Conversion of measured J_{3u} and J_{RMS} to A_{DD} and σ_{RJ}

IEEE P802.3ck Task Force Ad Hoc Meeting
April 14, 2021

Zero DJ Cases ($A_{DD} = 0.00$ UI)

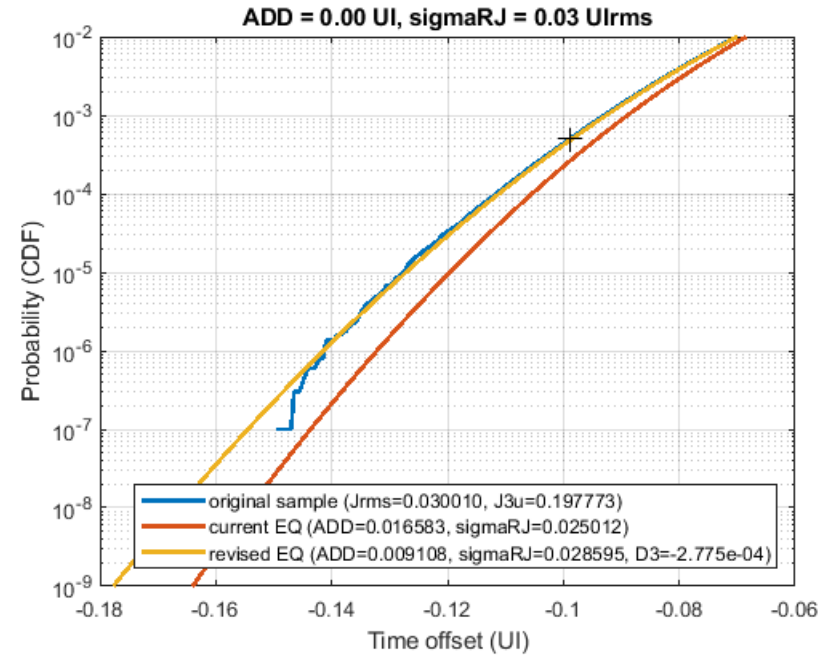
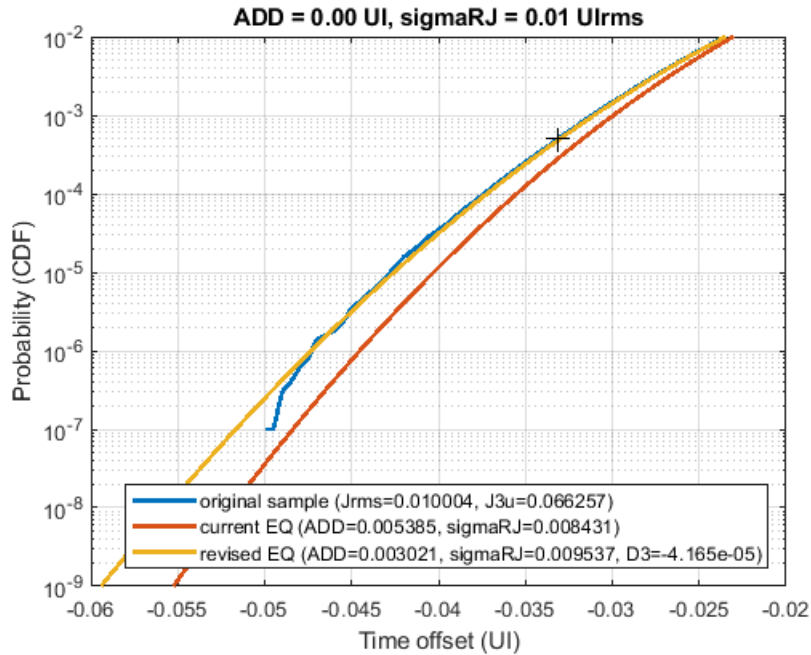
Re-constructed dual-dirac distribution does not match with original distribution. (e.g. does not have the same J_{3u} .)

- ❖ Change Equation (163-2) and (163-3) with equations in slide 4.
- ❖ Same change for Equation (162-7) and (162-8).
- ❖ Change Annex 120F.3.2.3 to use a variant of equations in slide 4 but for J_{4u} .
